MR. Barry Estrin:

I photo-copied a picture of one of your existing XP-100 TBR. + have sketched in a couple of suggestions to which I would like to see incorporated for a 1st. Class production pistol.

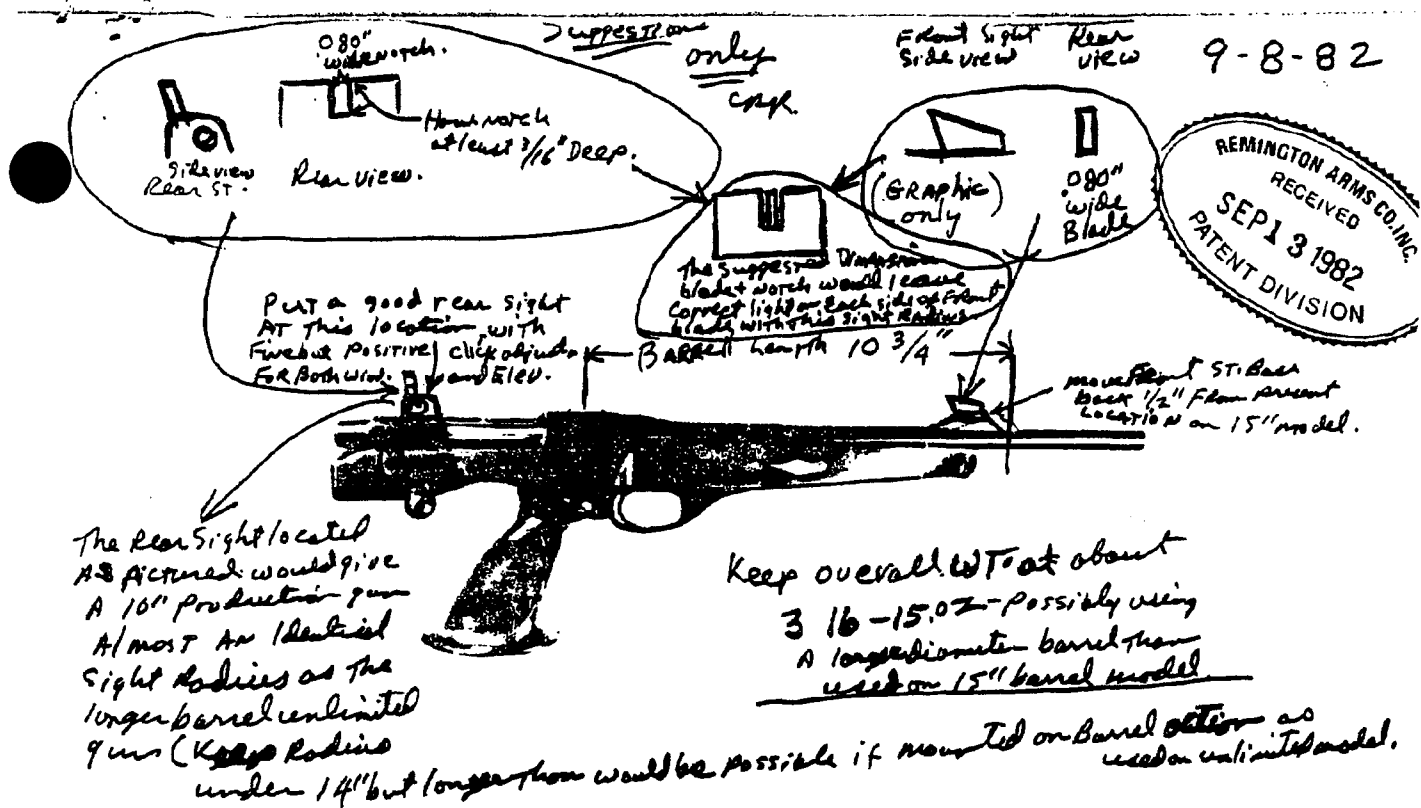
I have emphasized the sights especially as in silhouette shooting that's what really makes a difference, providing of course you have an accurate pistol.

At present production rules don't give a limit on sight radius but obviously they wouldn't allow a longer sight radius than used on the unlimited guns. hope you can my info. information kindly Connel R. Robertson
